BOARD OF ZONING APPEAL

BZA Number: 177687

LOCATION OF PROPERTY: 40 Valentine St, Cambridge, MA

Propose rear 3rd story addition by raising the rear roof ridge to match front roof to allow head room in side within Rear setback and increase FAR.

162 PEARL - *East Facade*

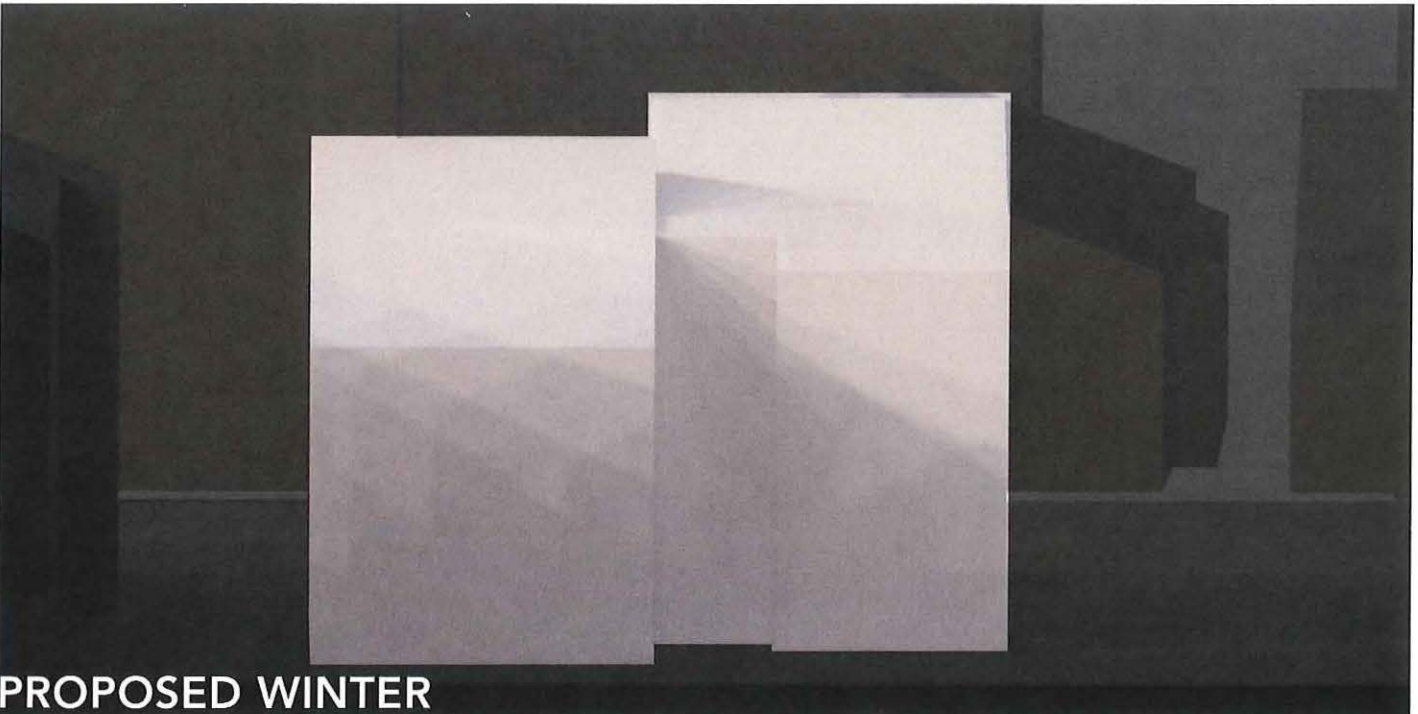
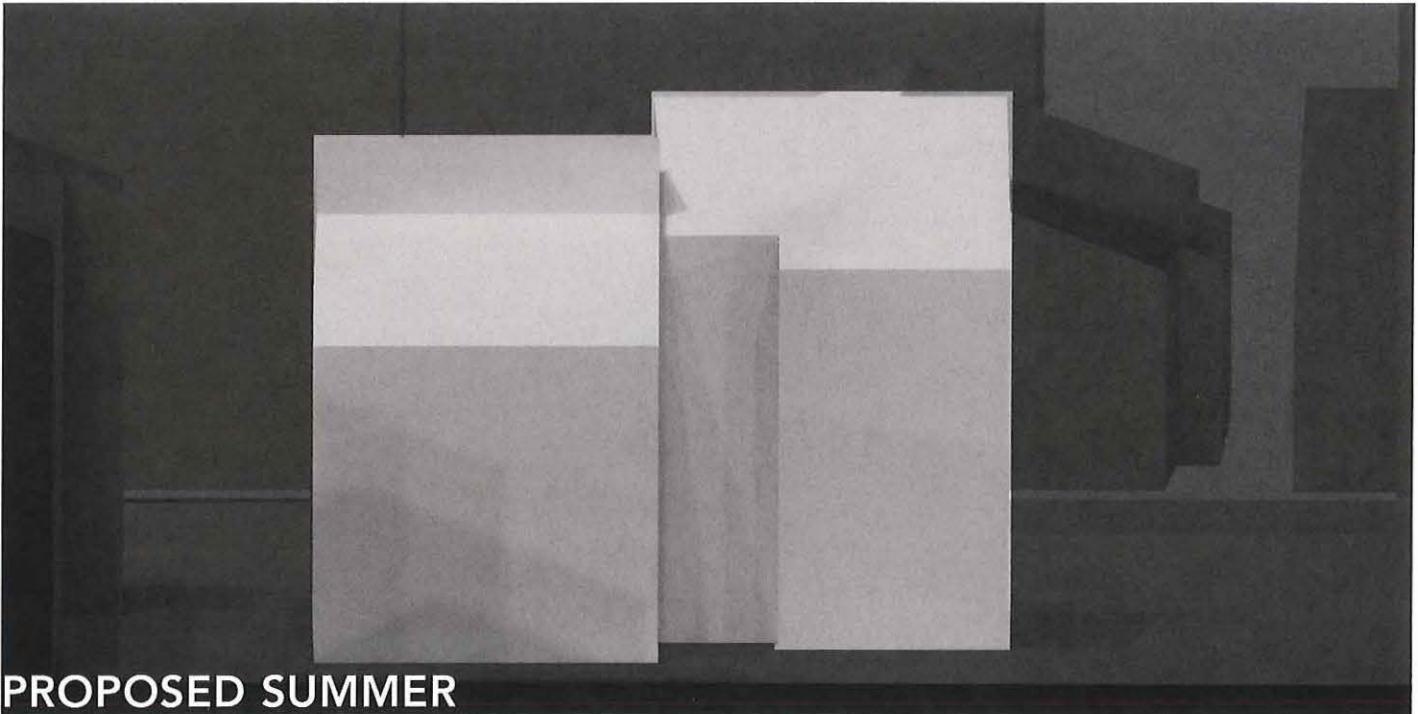
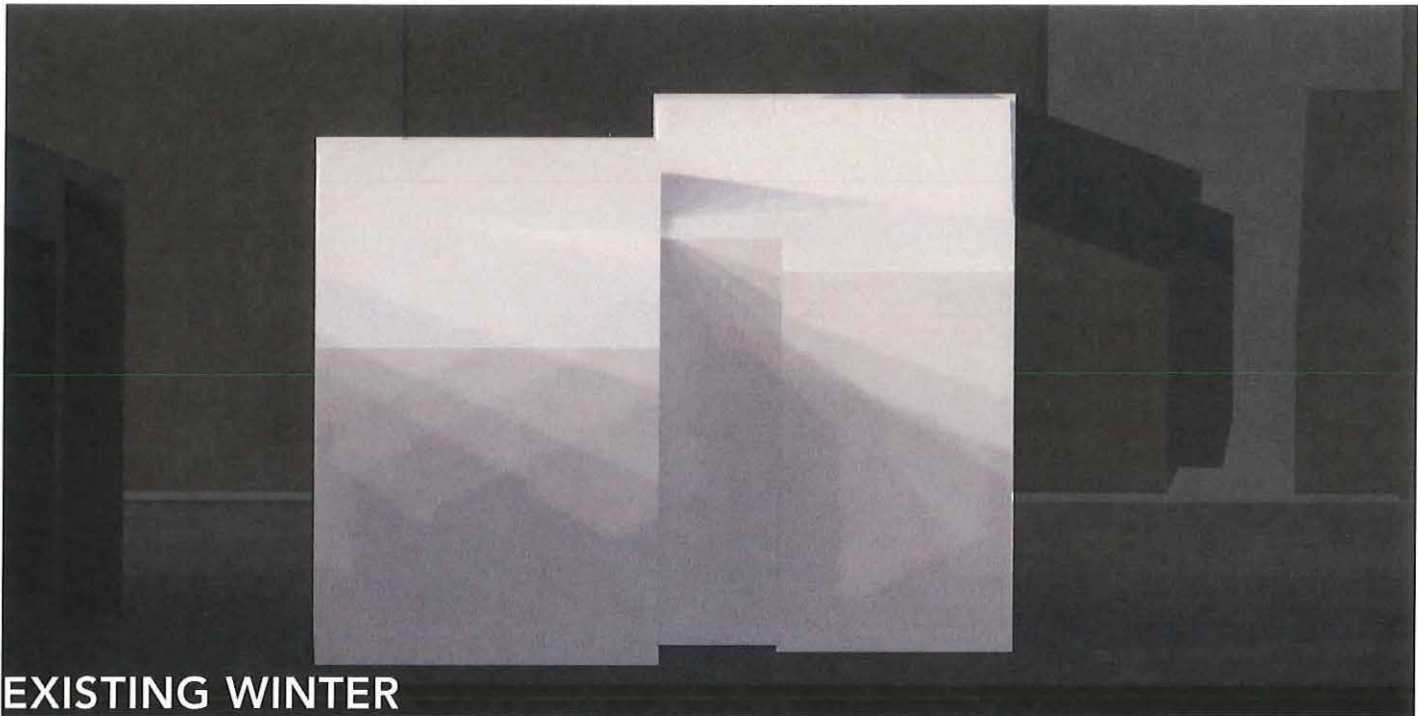
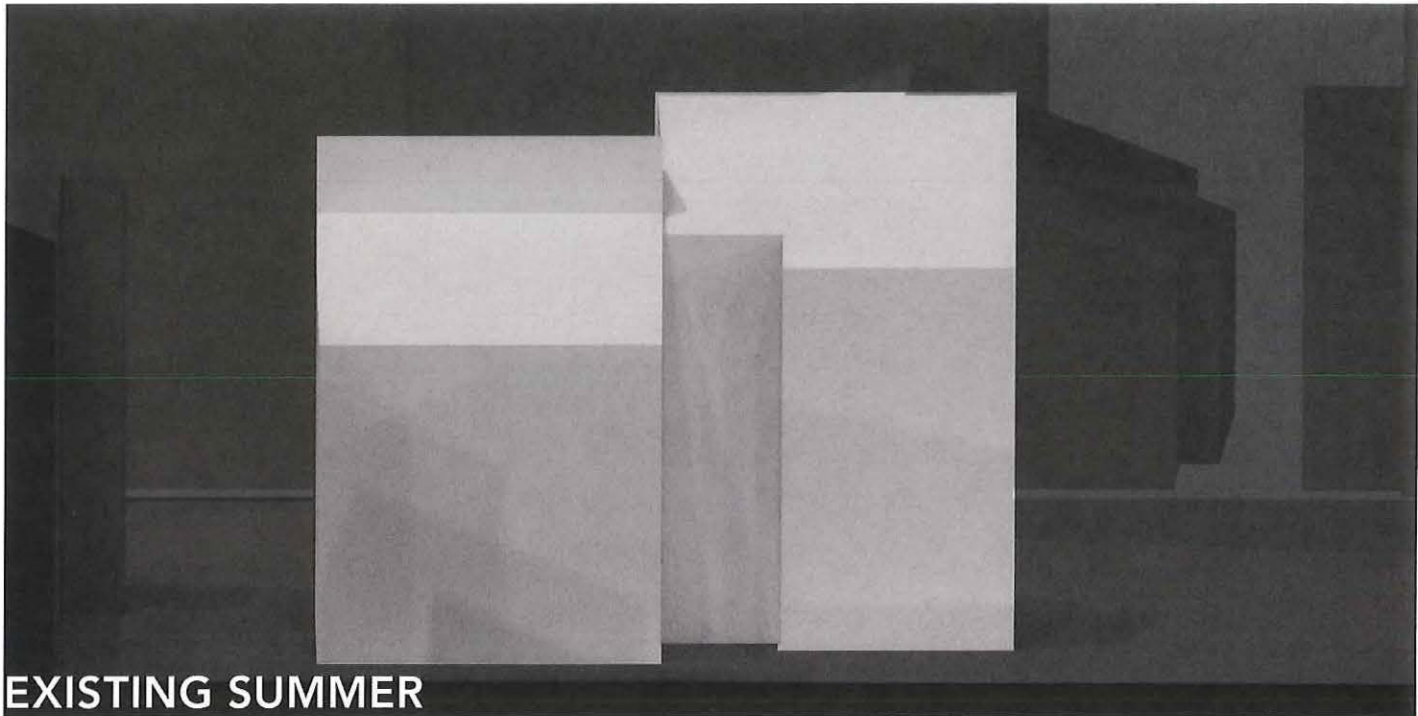
The petitioner states in their variance request that “ There will be no detriment to the public good as a result of the proposed roof raise. A similar variance has been previously granted to applicant's immediate abutter”. We strongly disagree with this statement and object to the comparison to a previous project that took place over a decade ago, as each project is unique and the effects of raising the rear roof peak 11’11” above the 3<sup>rd</sup> floor elevation to match the existing front roof peak will have significant detrimental impacts on neighbors, including our property. The additional building massing will create a cavernous effect to abutting properties while also blocking the already reduced available sunlight, essentially eliminating any natural sun light from entering the windows of abutting properties. The consequences of this 3<sup>rd</sup> floor addition are deeply disturbing. This change in roof line is a substantial design change and clearly diminishes the original architectural intent of designers Bell and Fandetti to utilize natural lighting. In addition, at a time when the City of Cambridge focuses on sustainable and local food production, the resulting reduction of available sunlight will have a measurable impact on our ongoing ability to grow produce on site. Also, as noted previously, we are obligated by deed to maintain and preserve, the mature flowering cherry tree located on our property and directly adjacent to this project, as depicted in one of the latter pages in the application package. This ornamental tree requires direct sunlight to thrive and would certainly be compromised as a result of the proposed project blocking the sunlight that it is accustomed to receiving. We take this responsibility as caretakers of this tree very seriously. It’s unclear to me if the applicant has performed any shading analysis or sun study related to the raised roofline’s impact on adjacent properties but I’d suggest that this would have been helpful in quantifying the proposed project’s impacts.

A shadow study is attached here. The "Aerial" view shows that the proposed work would not impact the open space given the current condition. The "East Facade" view focuses on the impact to your unit. The shadow pattern is not changed over your existing windows on the east side facing my unit. Also, I believe there are two skylights for your unit and the study shows there is no impact for them. One note, I think the pine tree in my backyard overgrows and extends over 20'+. It has a huge impact to both block sunlight to your unit and a danger to 42 Valentine in the event of storms. I have mitigated the risk by trimming down 7' to the same height as the front roof ridge as 42 Valentine. The tree can be further trimmed to clean the path for sunlight.
